# Site Audit Report 278\_PBR by Dr Ian Swane

WESTCONNEX STAGE 3A PYRMONT BRIDGE ROAD WORKSITE (AREA C9)

Final | 25 NOVEMBER 2022

Document title: Site Audit Report 278\_PBR

Figure 2-5 2018 Layout of 79 PBR

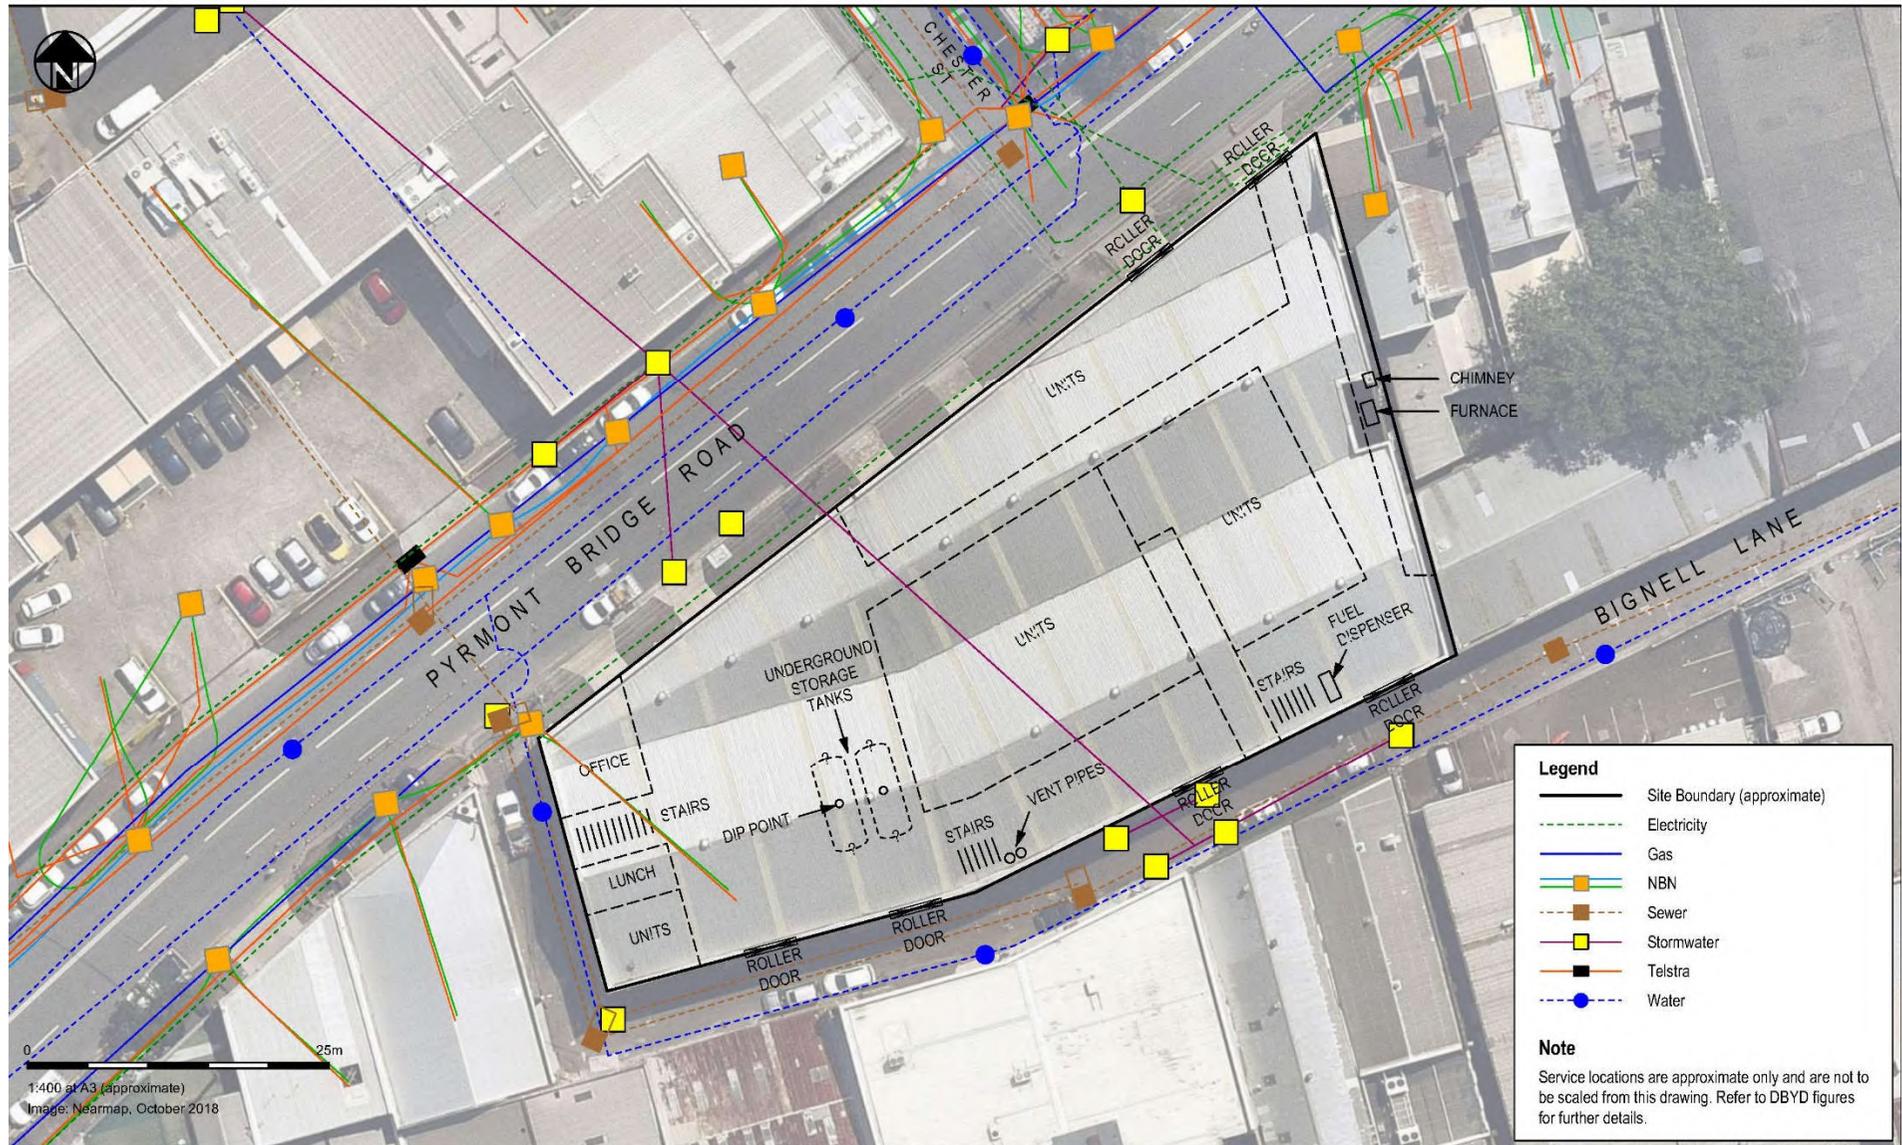
- 79 PBR: Two underground storage tanks (USTs) were located on site by a service locator in the SW end below the carparking area (**Figure 2-5**). Two external vent pipes from the UST and two dip points on top of the USTs were visible. The USTs have been dipped, with the dipstick indicating one UST was partially filled with water and one partially filled with sand. The fuel bowser was located at the opposite end of the area, up to 50 m from the USTs. Connection between the UST and bowser was not confirmed; and
- Stage 2 area: A UST was present in Property 5 in the groundfloor carparking area. The tank was dipped and filled with water, with a slight hydrocarbon odour detected on the dipstick.

- Details of any relevant local sensitive environment – e.g. rivers, lakes, creeks, wetlands, local habitat areas, endangered flora and fauna
- c) Explain why the UST locations shown in Figure 4 of the SESL (March 2019) report are different to those shown in the Alliance DSI report !!

Figure 2-6 UST Locations Reported in Alliance 2019 DSI

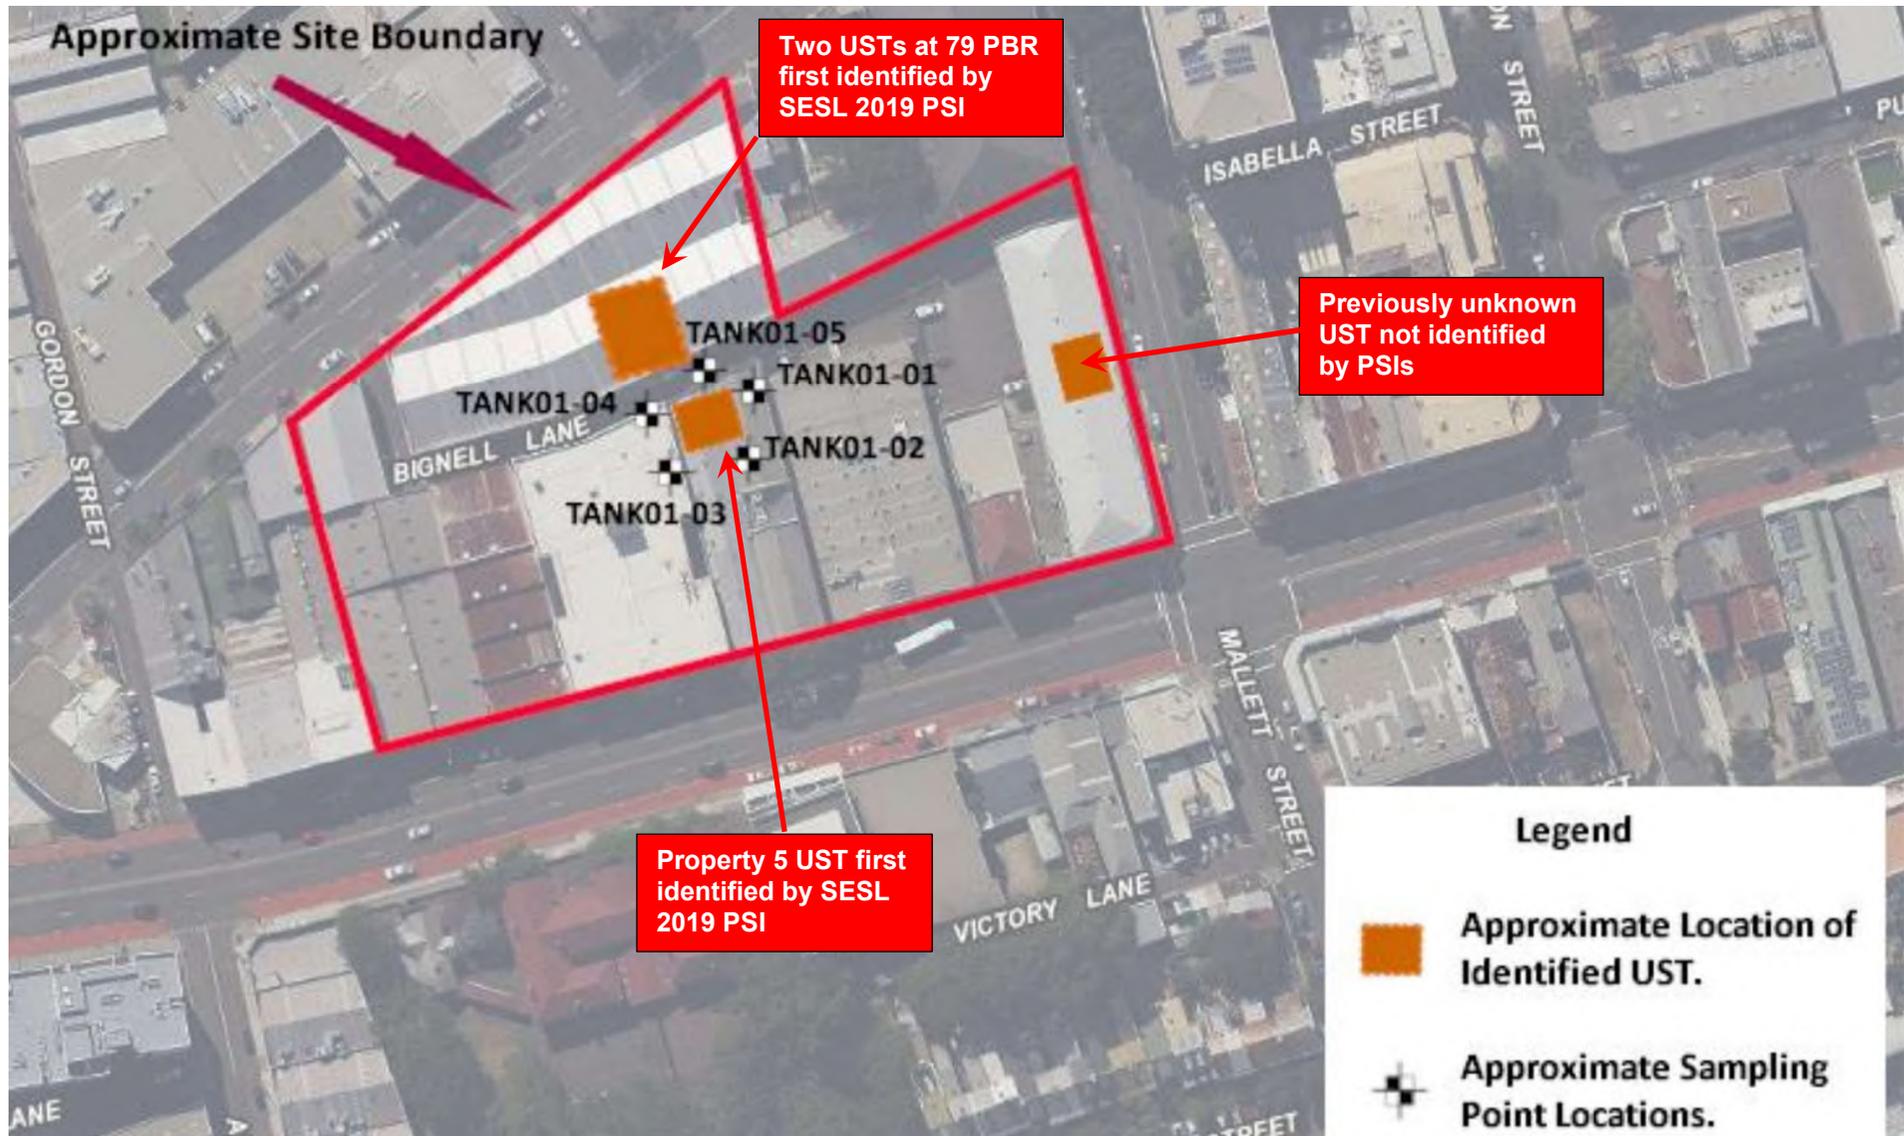
An additional UST was reported in the Alliance 2019 DSI at the eastern side of the Stage 2 area (**Figure 2-6**), but no further details were provided.

- a) Provide detailed information on the USTs observed at the site and associated contamination;
- b) Explain why the UST locations shown in Figure 4 of the SESL (March 2019) report are different to those shown in the Alliance DSI report !!

Figure 3-6 Photo of Unexpected UST found at Property 1 on 25/02/19 (Source: Comment 16, Ref [6])

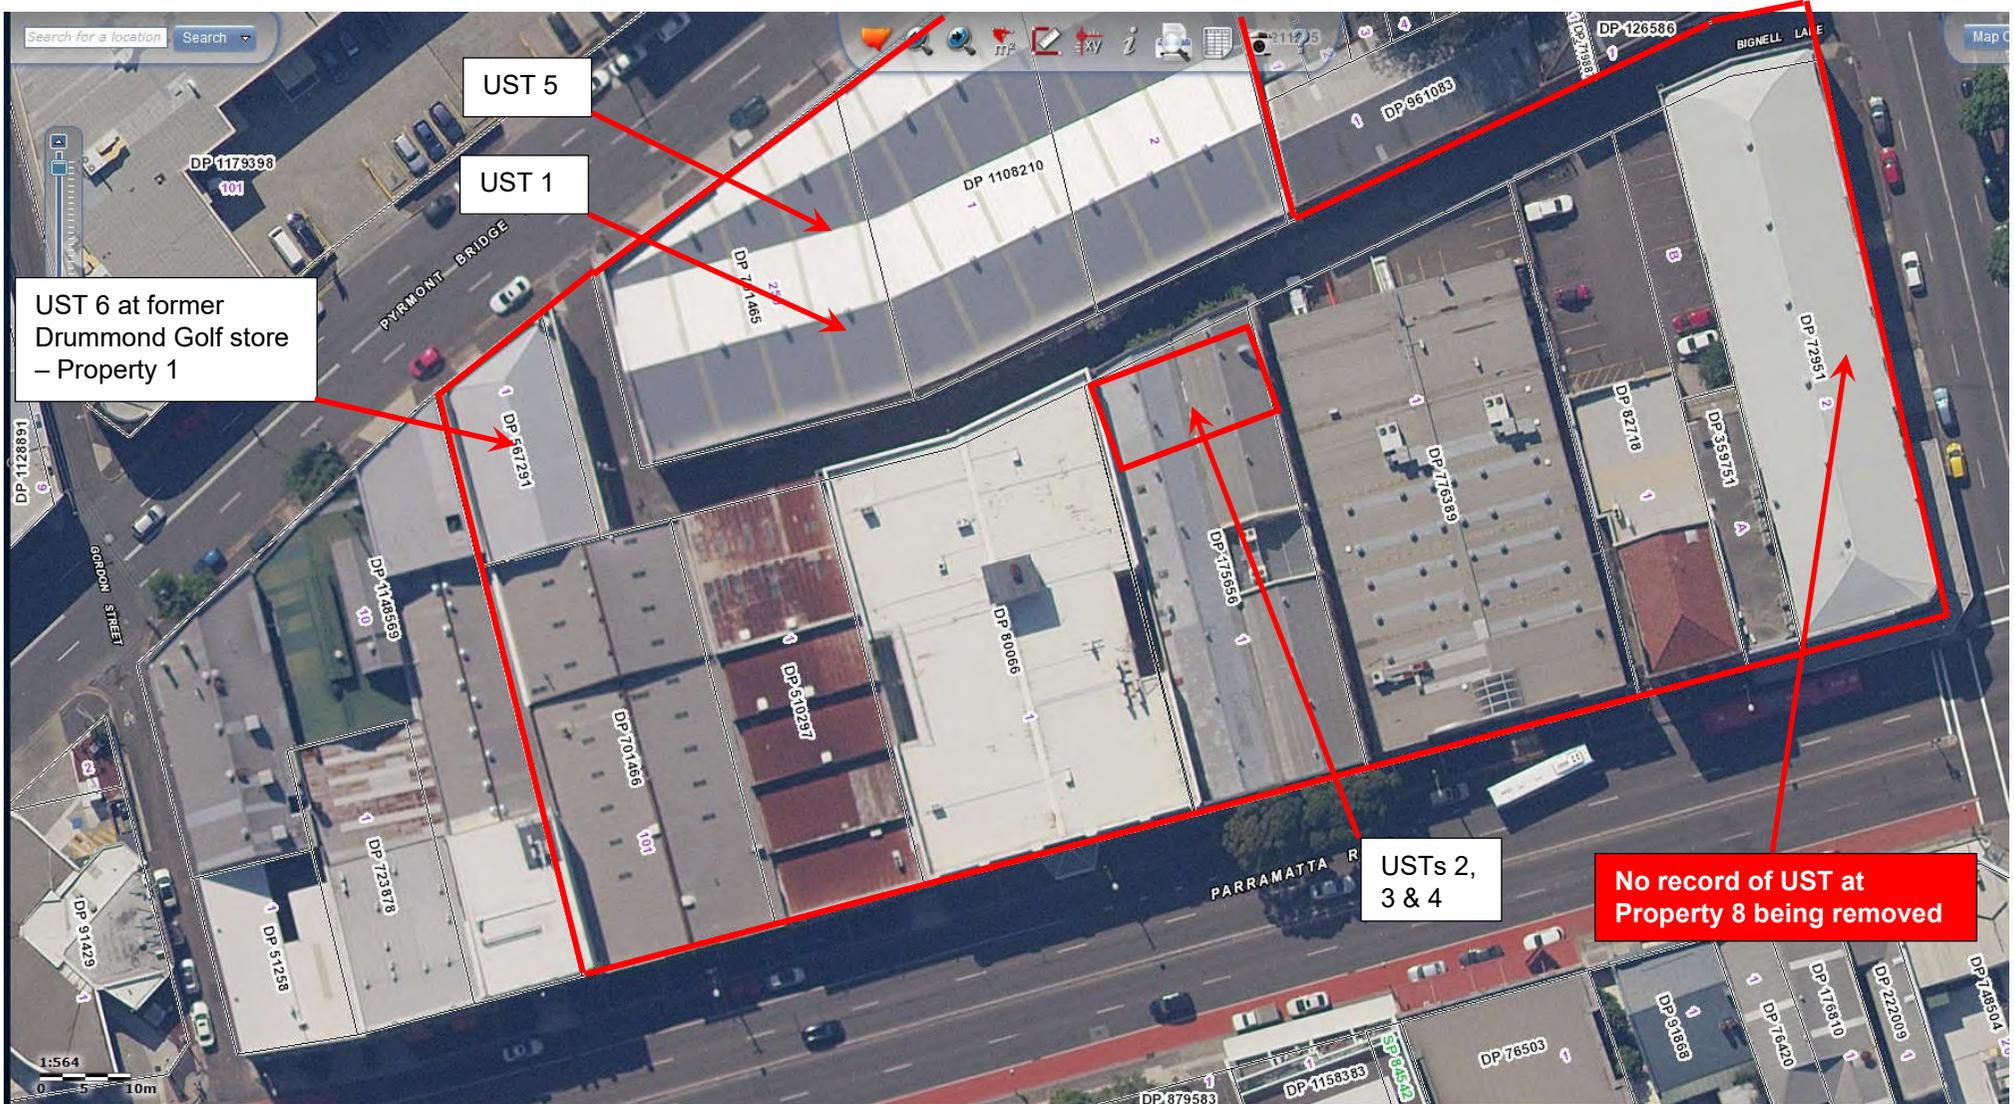
- 25/02/19: A photo taken by the ASBJV site supervisor / engineer of a UST found at the former Drummond Golf store at Property 1 located in the NW corner of the PBR site, with a copy provided in **Figure 3-6**;

- No methodology was provided showing how ASBJV identified USTs at the Site;
- No documentation was provided on whether the UST at the eastern part of the Site (Property 8) was removed; and
- The layout of construction work at the PBR site (**Figure 1-5**) showed that no large scale excavation or ground disturbance work was required at the eastern end of the 79 PBR area or the eastern end of the Stage 2 area. It was possible that an unknown UST may remain below the old concrete ground slab.
